MILITARY SPECIFICATION

MODULES, STANDARD ELECTRONIC

CONVERTER, D/A, KEY CODE MKR

This amendment forms a part of Military Specification MIL-M-28787/333(EC), dated 8 June 1982, and is approved for use by the Naval Electronic Systems Command, Department of the Navy, and is available for use by all Departments and Agencies of the Department of Defense.

FIGURE 6. Input clamp diode voltage (negative) test circuit for table V.

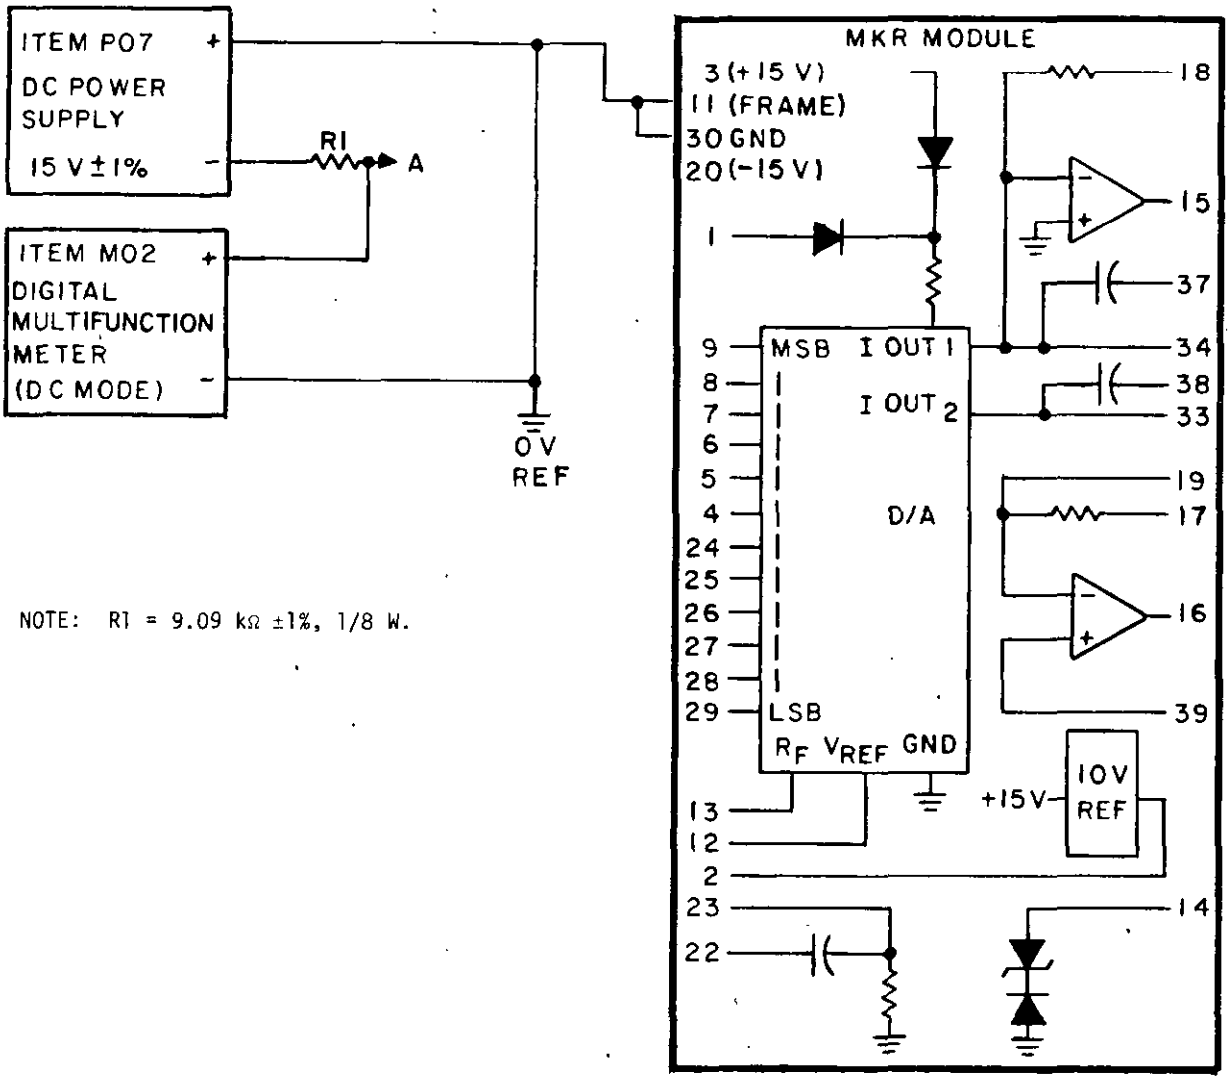
FIGURE 6: Delete and substitute new figure 6 as printed on page 3 of this amendment.

FIGURE 16. Gain frequency response check and distortion test circuit for tables XVI and XVII.

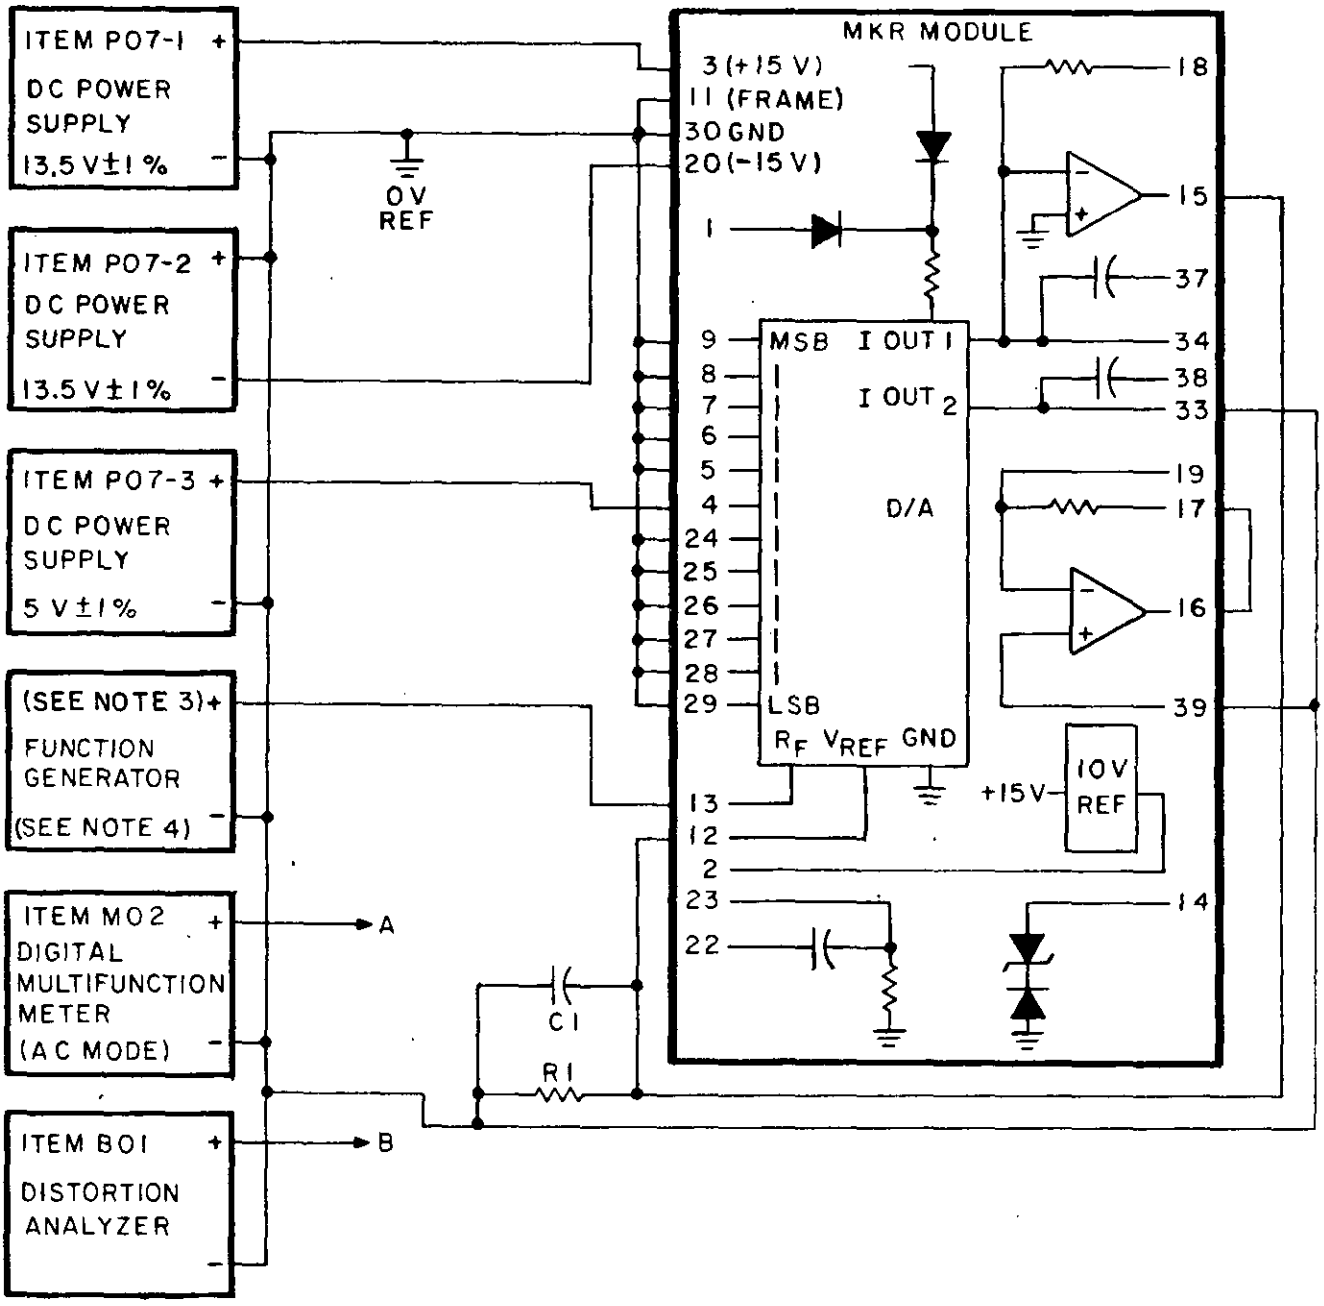
FIGURE 16: Delete and substitute new figure 16 as printed on page 4 of this amendment.
